DEPARTMENT OF TRANSPORTATION**National Highway Traffic Safety Administration****49 CFR Parts 571 and 585**

[Docket No. NHTSA–2011–0004]

Federal Motor Vehicle Safety Standards, Ejection Mitigation; Phase-In Reporting Requirements; Incorporation by Reference

ACTION: Final rule.

Figure 5 - Alliance Displacement Measurement Method.

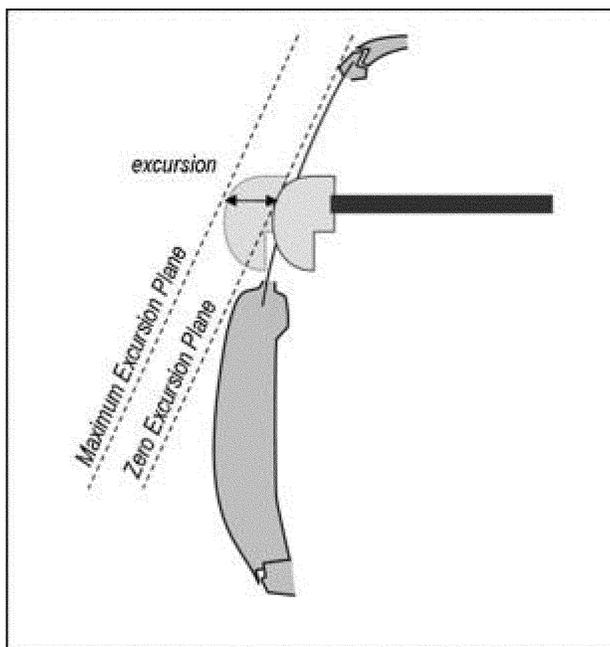
Both the Alliance and AIAM suggested that the final rule measure displacement from an initial reference point other than the point of contact of the headform with the glazing. Both requested that a method similar to that used by GM be used. This measurement method defines a line tangent to the side of the vehicle at the window opening. (We note that although the Alliance calls the longitudinal plane that passes through this line the excursion plane, see Figure 5, extracted from the Alliance comments, there would likely be a unique excursion plane at every target location due to the curvature of the vehicle sides.)

excursion plane by 100 mm along a line normal to the excursion plane, rather than 150 mm laterally.

commenters and compare the associated performance limits of the respective methods to the performance limit discussed in the NPRM. For this comparison, we used a graphical representation of a two dimensional lateral cross-section of the headform contact with the side window. For convenience, we used an approximation of the headform profile rather than the exact cubic equation prescribed in the NPRM. The vehicle cross-section included the window as well as the structure in its vicinity.

Figure 6 – NPRM Displacement Measurement at Target A2

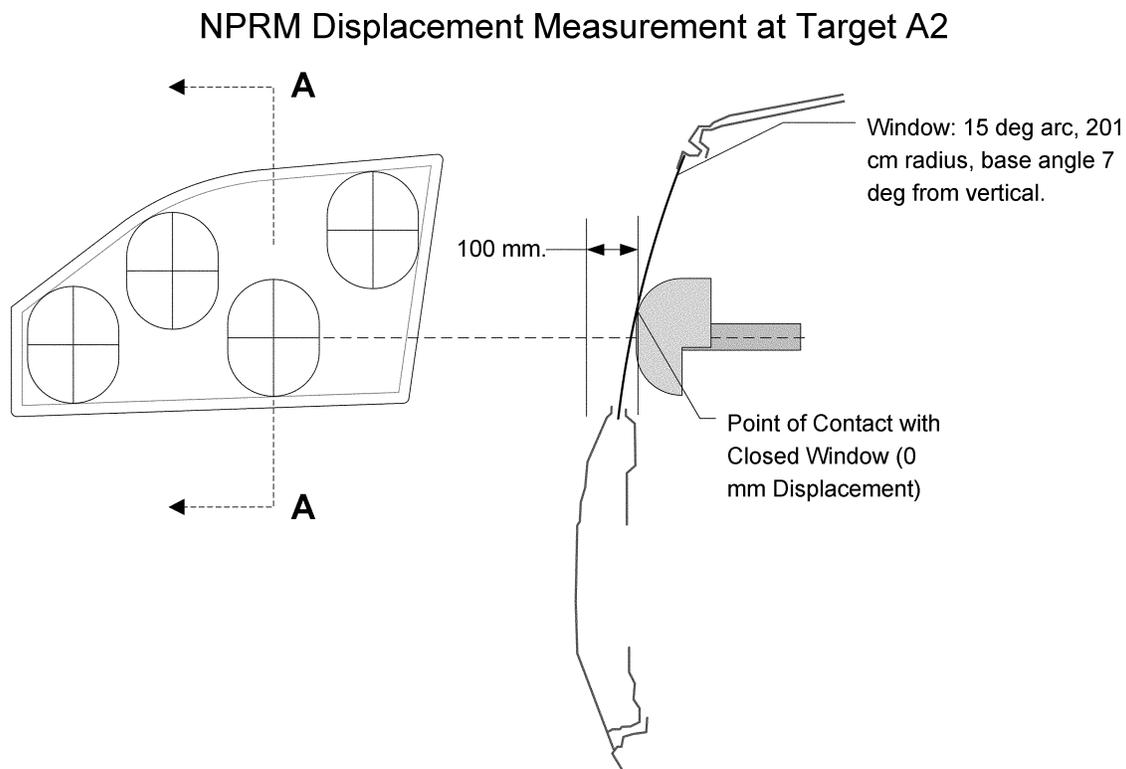
Figure 6 shows how the 100 mm displacement put forward in the NPRM is measured from the contact point of the headform at the A2 target point with the side window glazing. In this example, the lateral cross-section A-A of the glazing is represented by a 15 degree arc segment having a 201 cm radius, with the base of the arc oriented approximately 7 degrees from the vertical.

Figure 7 – Suggested Honda and Alliance Methods at Target A2

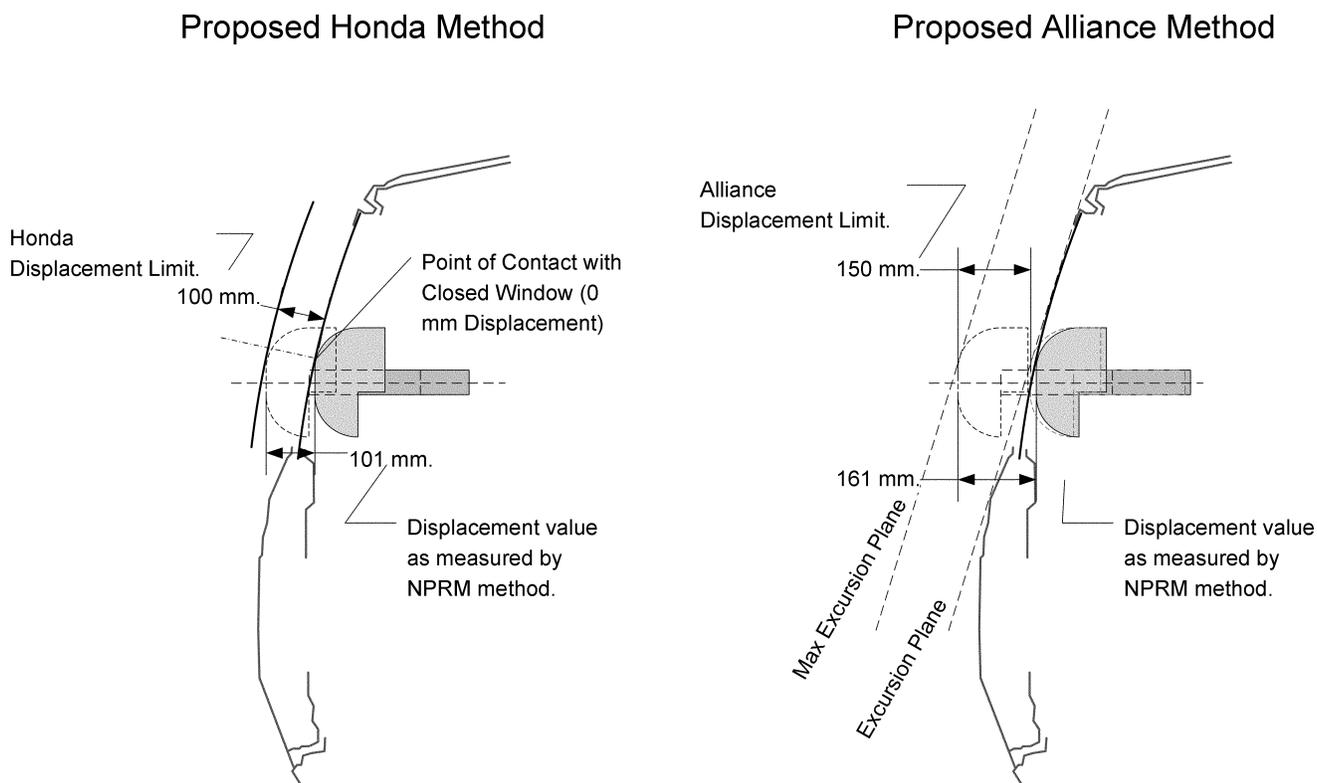
Figure 7 shows the displacement measurement methods that Honda and the Alliance recommended in their comments. In the Honda method, the lateral cross-section of the glazing is projected 100 mm along the normal line at the point of contact of the headform. Using the Honda method, the headform's horizontal displacement at

headform's horizontal displacement at the A2 target is 161 mm from the NPRM zero displacement point. This 161 mm value is the sum of the 11 mm distance between the contact point with the window and the excursion plane (Δ excursion plane) and the 150 mm

AIAM also recommended a displacement measurement method similar to the Alliance method in that an excursion plane is located tangent to the side of the vehicle window opening. However, the maximum excursion plane is defined by translating the excursion plane by 100 mm along a line normal to the excursion plane rather than 150 mm laterally.

the limit determined by the Alliance method. From Figure 7 we see that the excursion angle is 17 degrees from the vertical. Thus, the horizontal translation of the AIAM maximum excursion plane is $105 \text{ mm} = 100 / \cos(17 \text{ deg.})$. The total AIAM displacement allowance from the headform when in contact with the window plane is the sum of the Δ Excursion Plane (11 mm) plus the horizontal translation of the excursion plane (105 mm), resulting in a value of 116 mm at target A2.

locations and window/vehicle geometries. However, there does not appear to be a situation where any of the suggested methods will result in a lateral displacement limit of less than

100 mm. That is, each suggested method would reduce the stringency of the test by permitting the openings to be greater than 100 mm. As explained in the section below, this we cannot accept.

Figure 8 – NPRM Displacement Measurement at Target A4

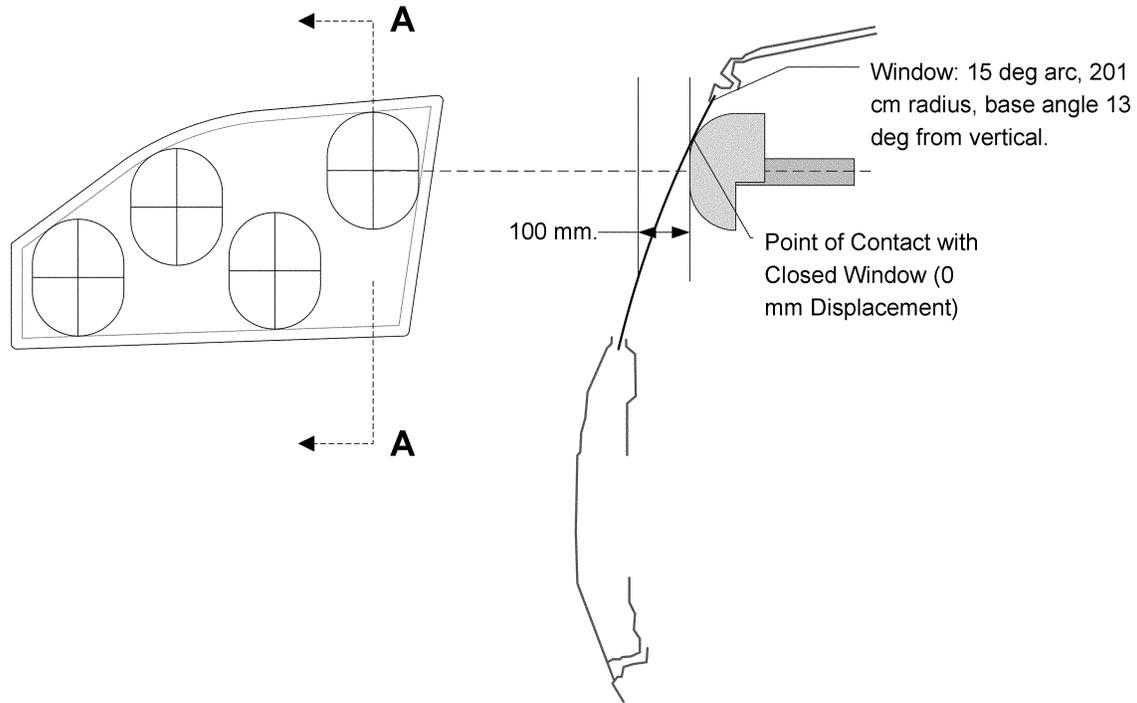
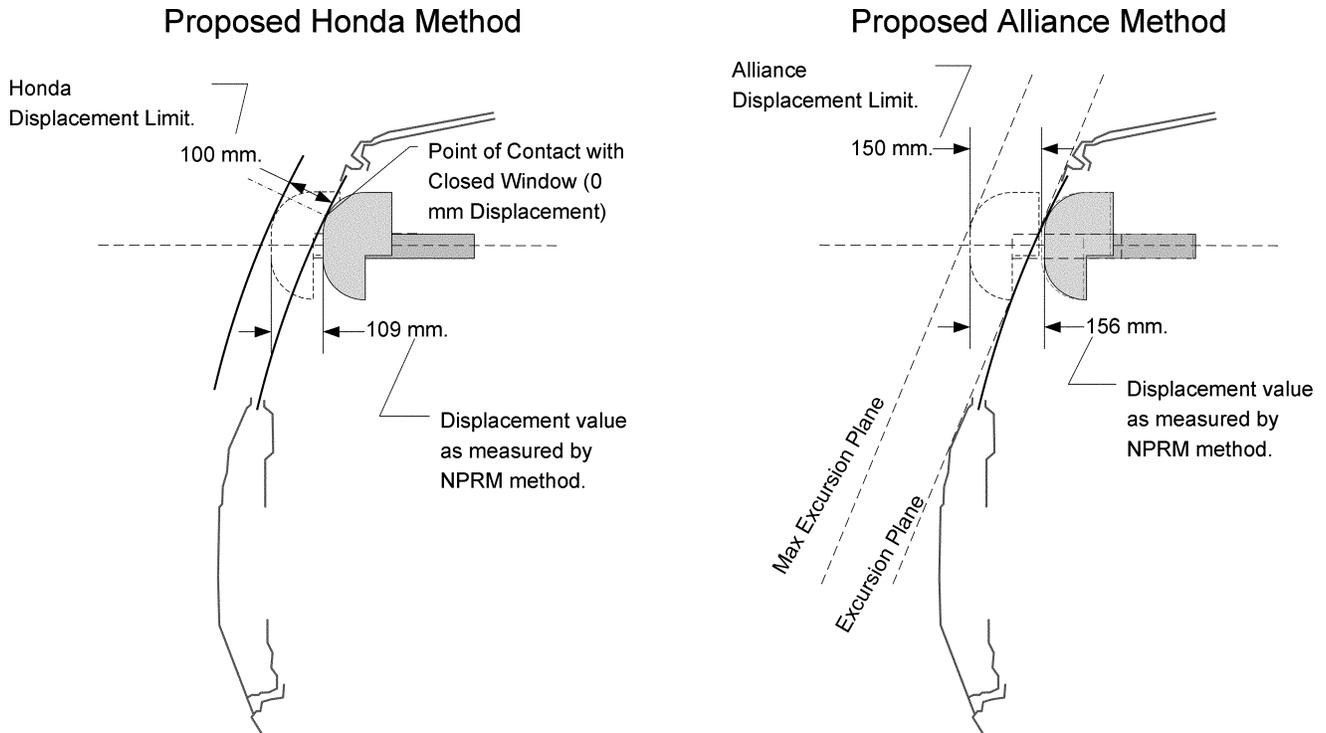
location, the curvature and angle of the window, as well as the profile of the vehicle structure around the window opening, than the NPRM method. Figure 8 shows the NPRM displacement measurement at target A4 for a side window having twice the base angle (13 degrees) as the previous example. The window curvature remains the same. Figure 9 shows a graphical determination of displacement measurements for Honda (109 mm) and the Alliance (156 mm) at A4. Using the mathematical transformation described above, we calculate the AIAM value (114 mm).

Figure 10 – Comparison of Displacement Measurement Methods

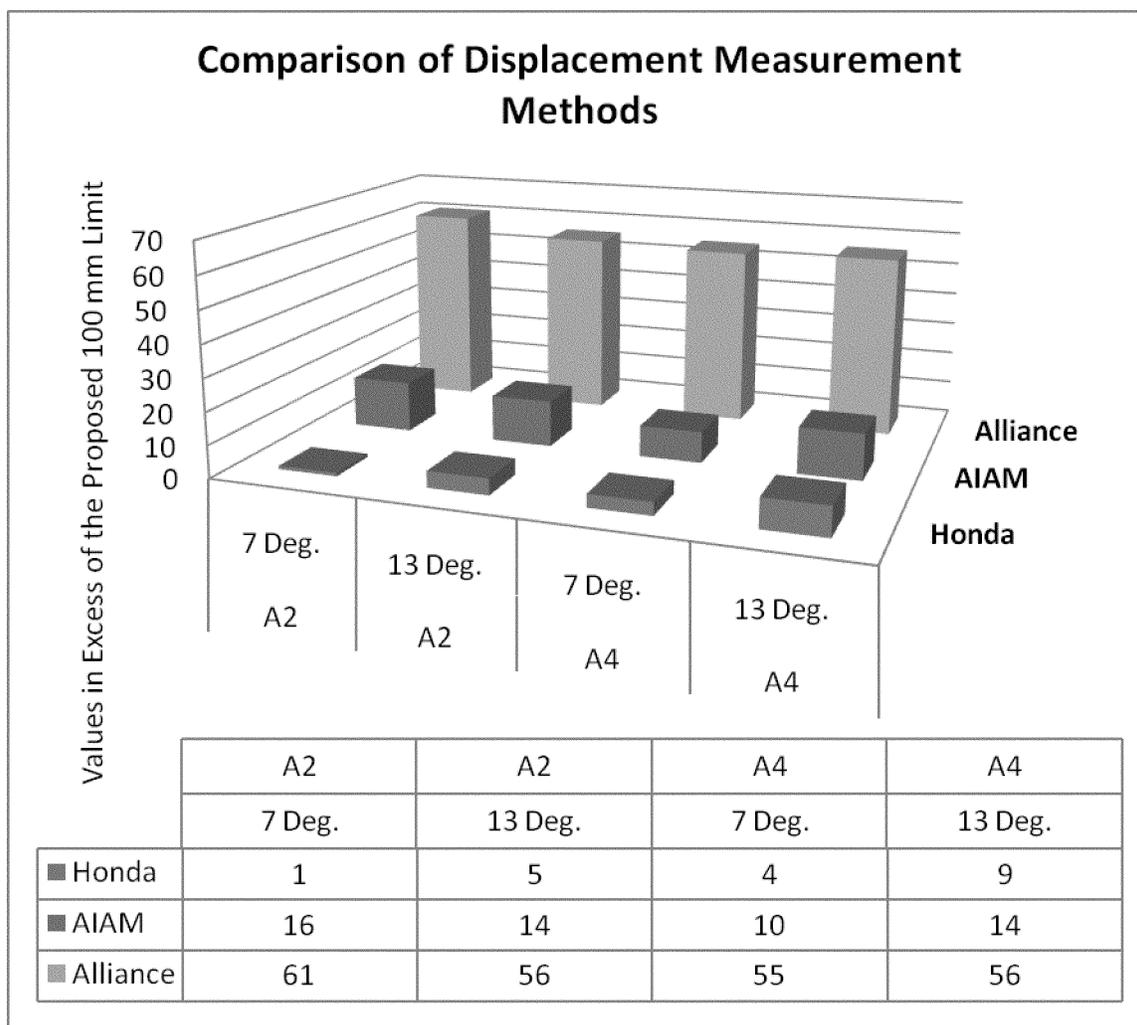
a 7 degree window. Figure 10 shows the displacement limits calculated for the three commenters' methods at target

Figure 11

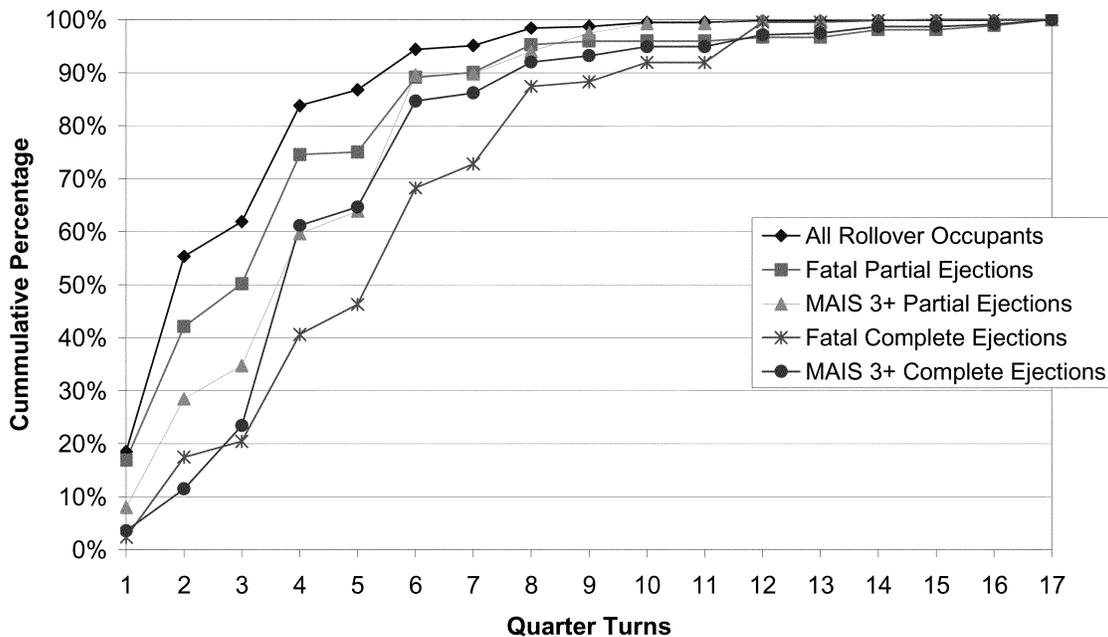
This information was illustrated in the NPRM by the Figure 11 below. The updated target population for this final rule shows that the vast majority of the ejection fatalities (69 percent = 3,067/

The Alliance indicated that a rollover time representing the cumulative percentage of at least 90 to 96 percent of rollovers is appropriate. Using this range of values and applying it to rollovers resulting in fatal complete ejections, the resulting number of quarter-turns is in the range of 10 to 12 quarter-turns for the 1997–2005 NASS CDS data and approximately 8 to 10 quarter-turns for the more recent 2000–2009 NASS CDS data. The Alliance showed a regression line through the quarter-turns versus rollover times for the agency’s full vehicle rollover test data (Table 11 in the NPRM). The commenter did not show the equation for the line. We derived the equation as $y = 0.48x$, where y = rollover time in seconds and x = number of quarter-

4,447) are complete ejections. This final rule is designed to mitigate ejections from rollover crashes that cause the most harm (those that result in complete ejection). By doing so, the countermeasures installed pursuant to this rule will reduce fatalities and injuries resulting from severe rollovers. Countermeasures installed to mitigate ejections in crashes with higher degrees of rotation will help occupants involved in those crashes as well as occupants exposed to rollovers of less severity. The inverse would not be true.

Figure 12 – Cross-section of a door and glazing providing an example of interior trim within 100 mm of the inside of the glazing opening dictating the daylight opening.

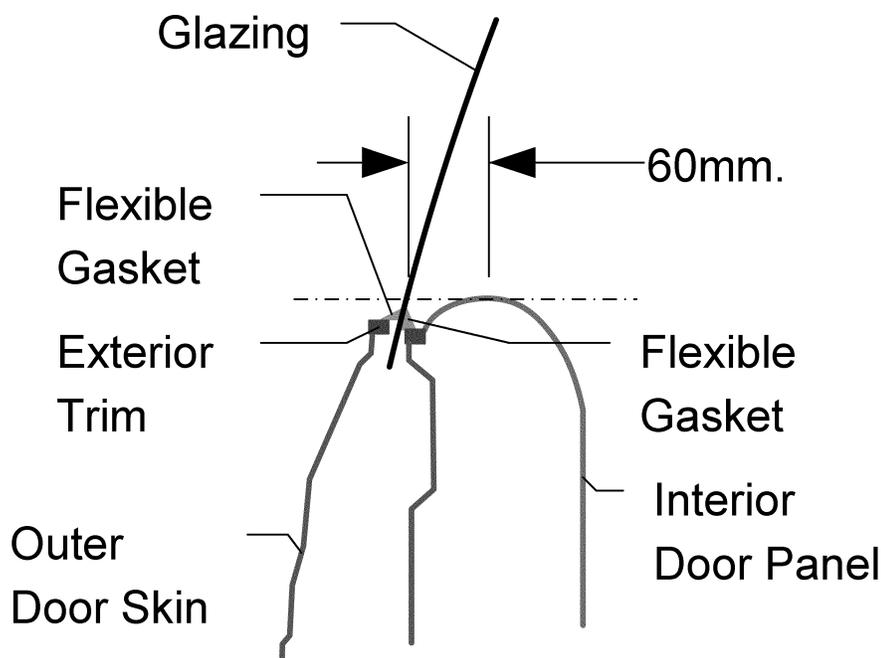
We believe the Alliance's request that the definition for side daylight opening be modified to increase the 50 mm distance inside the window has some merit. We have examined interior trim components, such as panels covering the vehicle pillars, and found that surfaces that should be considered as part of the outline of the daylight

opening can be more than 50 mm inside the window glazing. Figure 12 is a schematic showing the cross-section of a hypothetical door panel and glazing whose horizontal tangent is 60 mm inside the glazing. Based on the vehicles we examined, we believe that increasing the distance to 100 mm will be sufficient to encompass interior borders and other components around the daylight opening that might not be easily removed and whose removal may have an unknown effect on the performance of the countermeasure. These components could have a positive effect on ejection mitigation, so our decision is that the determination of the side daylight opening should be made with the components in place.

We will not increase the distance to 200 mm, however. A 200 mm distance is excessive and potentially includes more vehicle components in the determination of the window opening periphery than necessary. Although the linear impactor travels along a lateral horizontal path, during a rollover, people moving towards the window opening would not. Objects 200 mm from the window opening may have no ability to limit the potential for ejection. The Alliance did not provide a rationale justifying a 200 mm limit.

Figure 13 – Result of Alliance proposal for rear window targets with a forward rake.

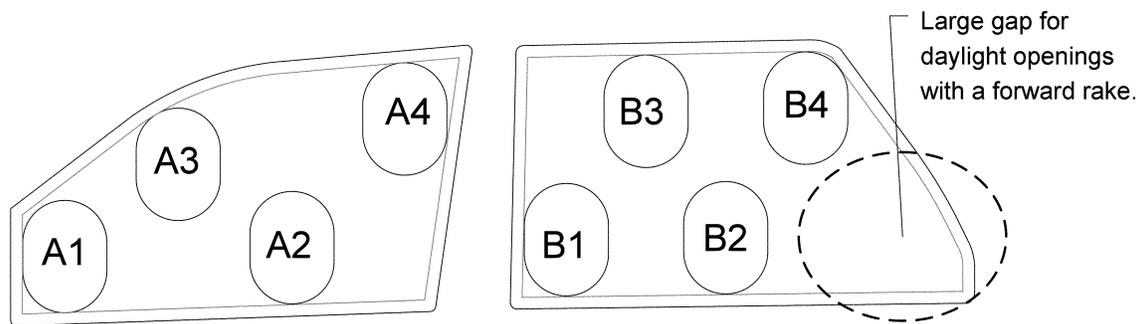
We are also declining the Alliance request to modify the target locations for rear windows such that they are the reverse of that proposed in the NPRM for rear windows. In Figure 13 below, illustrating the suggested Alliance targeting, it is shown that the Alliance procedure targeting can provide a large gap for daylight openings with a forward rake. It is our experience that, to the extent that the rear windows have a rake, this rake is forward. For rear window openings, matching the front window pattern creates a large gap of coverage, as shown in Figure 13. Further, the Alliance methodology crowds the targets closer together, raising the potential for forcing the elimination of targets based on the target reduction methodology. We are not aware of any reason why it is important to have consistency between the protocol used in the front and rear windows. Accordingly, we are denying the Alliance and Batzer and Ziejewski requests.
